100 GRAY'S INN ROAD

PLANNING RESPONSE

07.03.2025

1.0 INTRODUCTION

Approved - South Elevation

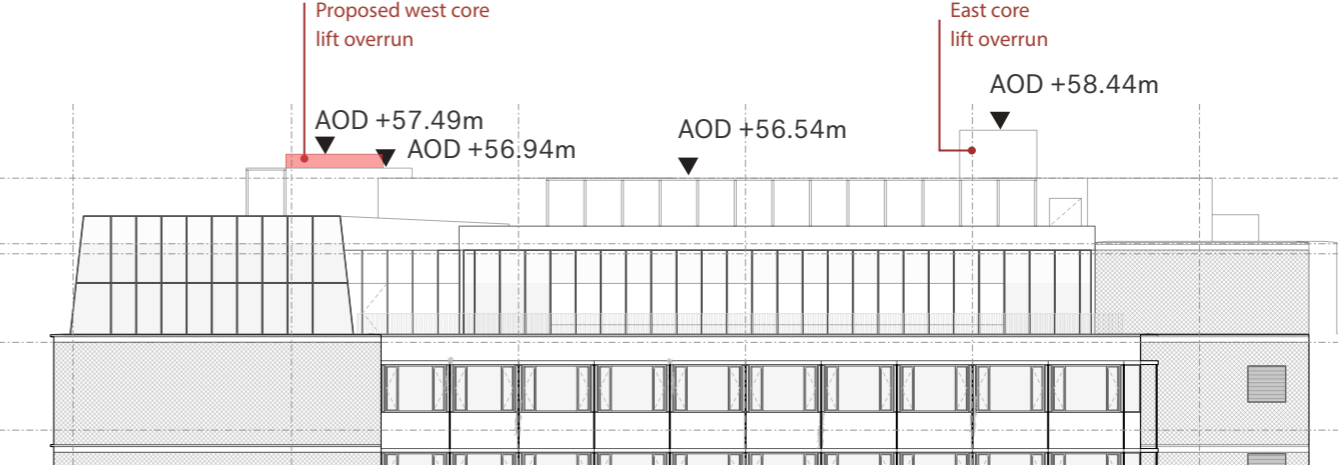
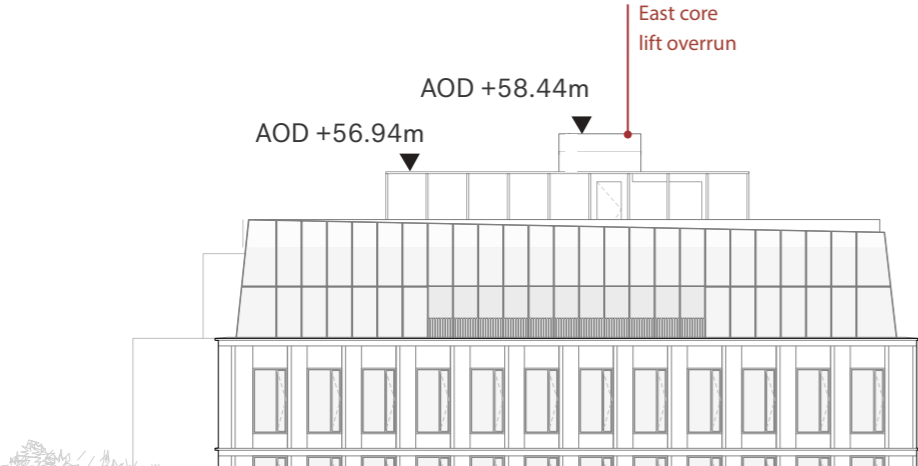
Furthermore, this document provides additional details regarding the materiality of the plant screen. To aid in the assessment of the proposed amendment, comparative roof plans and western elevations have been included to illustrate the massing of this element.

Approved - West Elevation

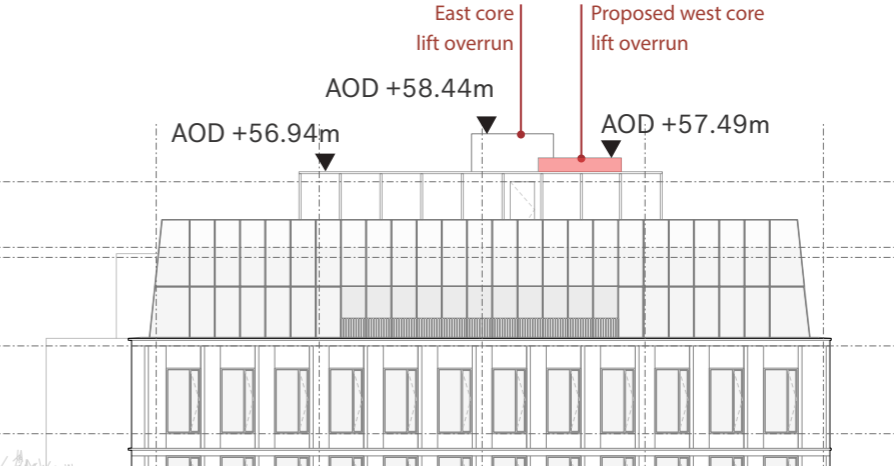
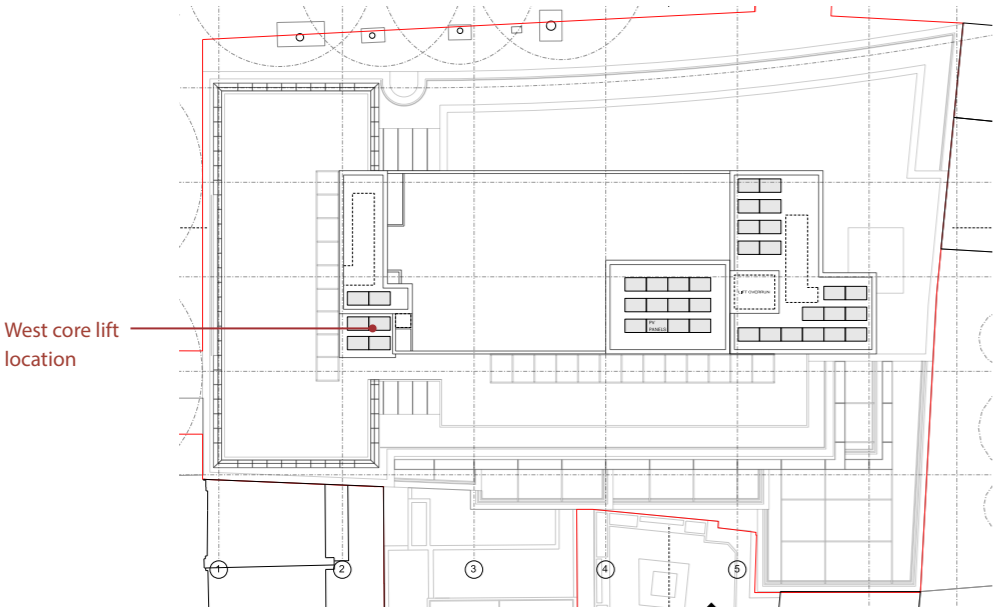
This document addresses the recent queries raised by the Case Officer regarding the non-material amendment (NMA) application for the development at 100 Gray's Inn Road and 127 Clerkenwell Road. The queries specifically concern the additional lift overrun height, particularly its visual impact when viewed from the west along Theobald's Road.

Plant Screen + Lift Overrun Cladding:
Aluminium perforated mesh with warm hue to match roof crown okalux glazing

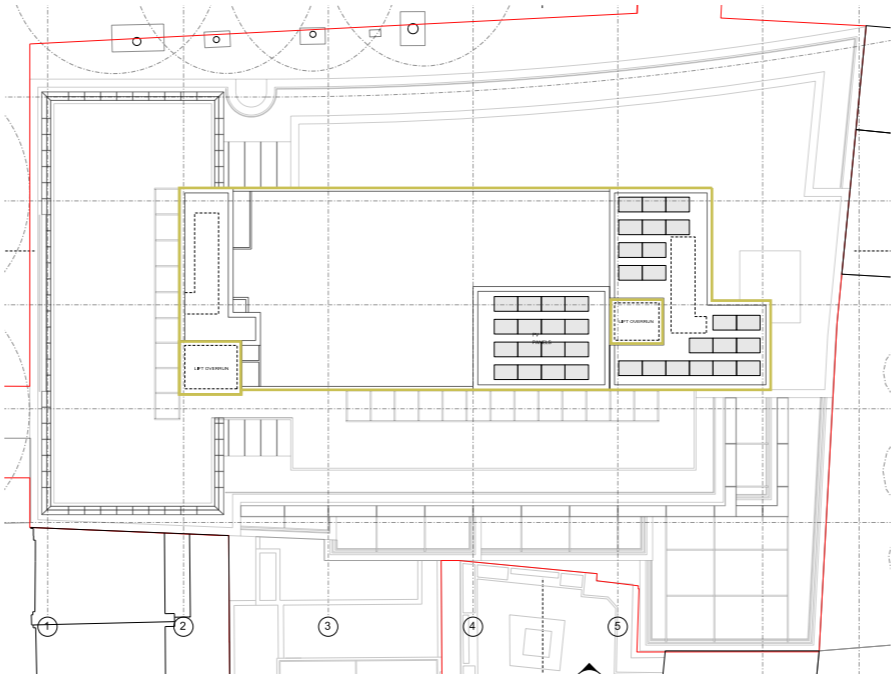
The images on this page illustrate the approved materials for the roof level plant screen and lift overrun.

The lift overrun will be clad in a perforated metal mesh, designed to have a similar hue to the roof crown glazing. Additionally, the reflective properties of the material will help blend the structure with the sky, minimising the visual impact of both the plant screen and lift overrun.

Roof Crown Curtain Wall Panel:
Okalux insulating glass panel with internal wire mesh

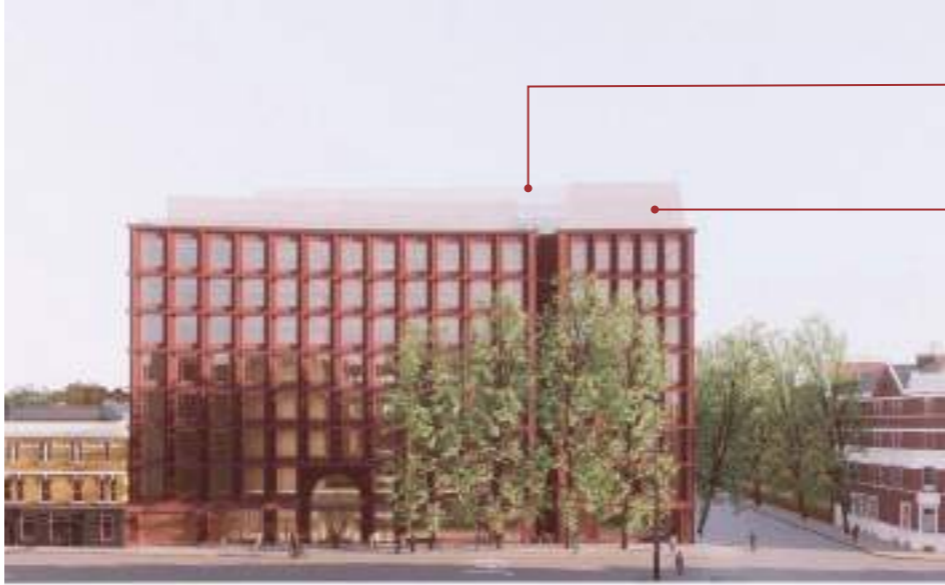
- Plant and lift overrun cladding with warm coloured perforated metal mesh
- Building 'crown' setback floor clad in curtain wall system with mandarin coloured metal mesh interlayer to glazing
